Intel® Xeon™ MP Processor

Specification Update

November 2003

Document Number: 290741-022

O1: BR0# Maximum Hold Time Specification Change

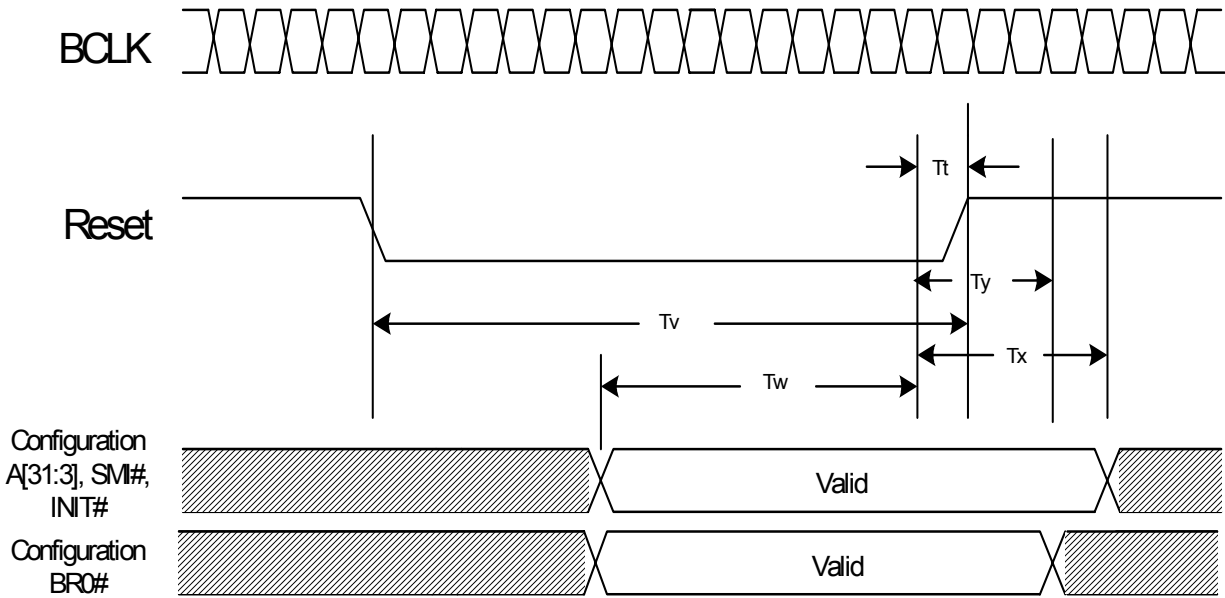
The BR0# maximum hold time has changed to 2 BCLKs. This change will be shown in the "System Bus AC Specifications (Reset Conditions)" table and "System Bus Reset and Configuration Timings" figure of the above mentioned datasheets. This change will be incorporated in the next revision of the above datasheets.

The following figure will be modified to reflect this change:

Signals (A[31:3]#, INIT#, SMI#) Hold Time					
T47: Reset Configuration Signal BR0# Hold Time	2	2	BCLKs	12	2
